**Before the Proposed Waitomo District Plan Hearing Panel**

In the matter of the Proposed Waitomo District Plan –  
**Tranche 2 Hearing Topics**

And **Transpower New Zealand Limited**  
Submitter 31 and Further Submitter FS30

**Statement of evidence of Pauline Mary Whitney for Transpower New Zealand Limited**

*Figure 1. Two single poles, circled in blue*

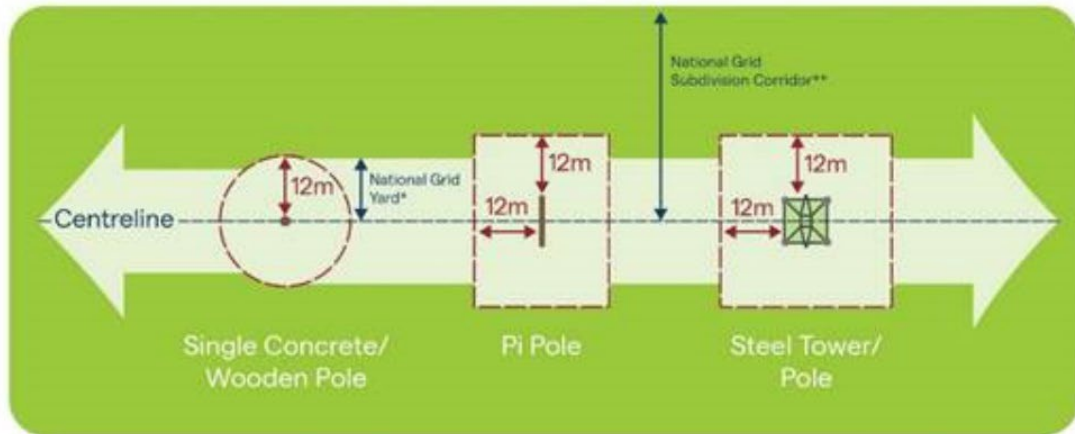
- As noted above, the setback from the centreline is determined by support structure type and voltage. Within the Waitomo context, the majority of support structure are towers. However there are eight pi-poles, and I do acknowledge two poles. Refer Figure 1.

the centreline to reflect this and provide a 10m setback from the centreline (not the structures) to reflect these two assets. However, given the 10m centreline setback would only apply for a distance of 110m (the distance between the two assets) I do not consider a change to the definition warranted given its very limited and confined application.

I note that Transpower does not treat pi-poles the same as single poles in terms of setbacks (on the basis of the 'swing' potential of the conductors in everyday wind conditions).

However, should the panel wish to amend the definition to accommodate the 110m distance between the two poles and provide a 10m setback from the centreline, the definition could be amended as follows: (refer [green](#) text). The suggested explanatory text is for clarification.

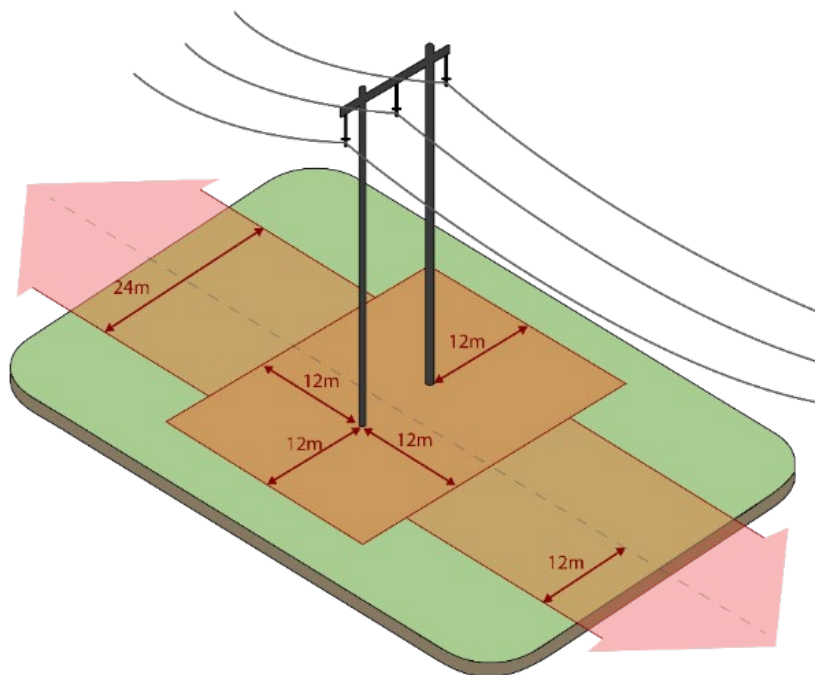
Delete the following diagram

Pi-Pole

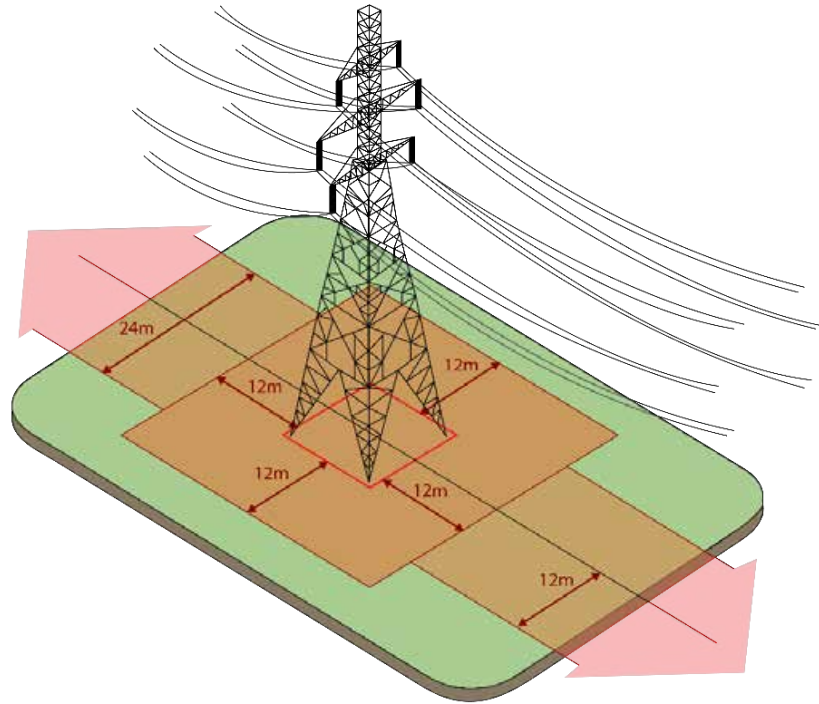
Insert the following diagrams to reflect the support structure type in the district
